SEWAGE DISPOSAL SYSTEM

HOWARD COUNTY HEALTH DEPARTMENT
BUREAU OF ENVIRONMENTAL HEALTH
410-313-2640

P 514932
A 49918-K
ISSUE DATE 2/13/2001
APPROVAL DATE 2/27/01

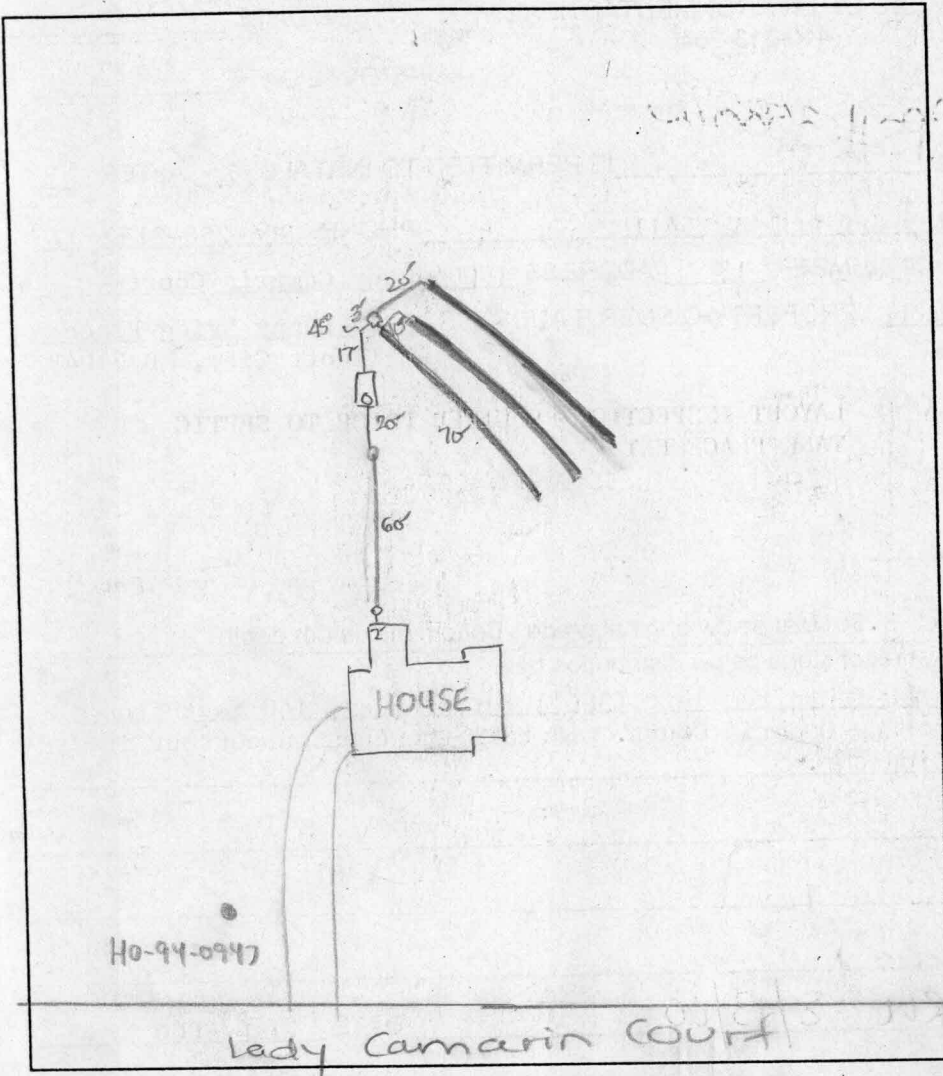
OK to run trenches in one direction. DKC

2/26/01 A.M. OK to cover from house to septic tank and first trench. Need to install 6" cleanout on septic tank. DKC

2/27/01 FINAL INSP - OK to cover all septic work. DKC
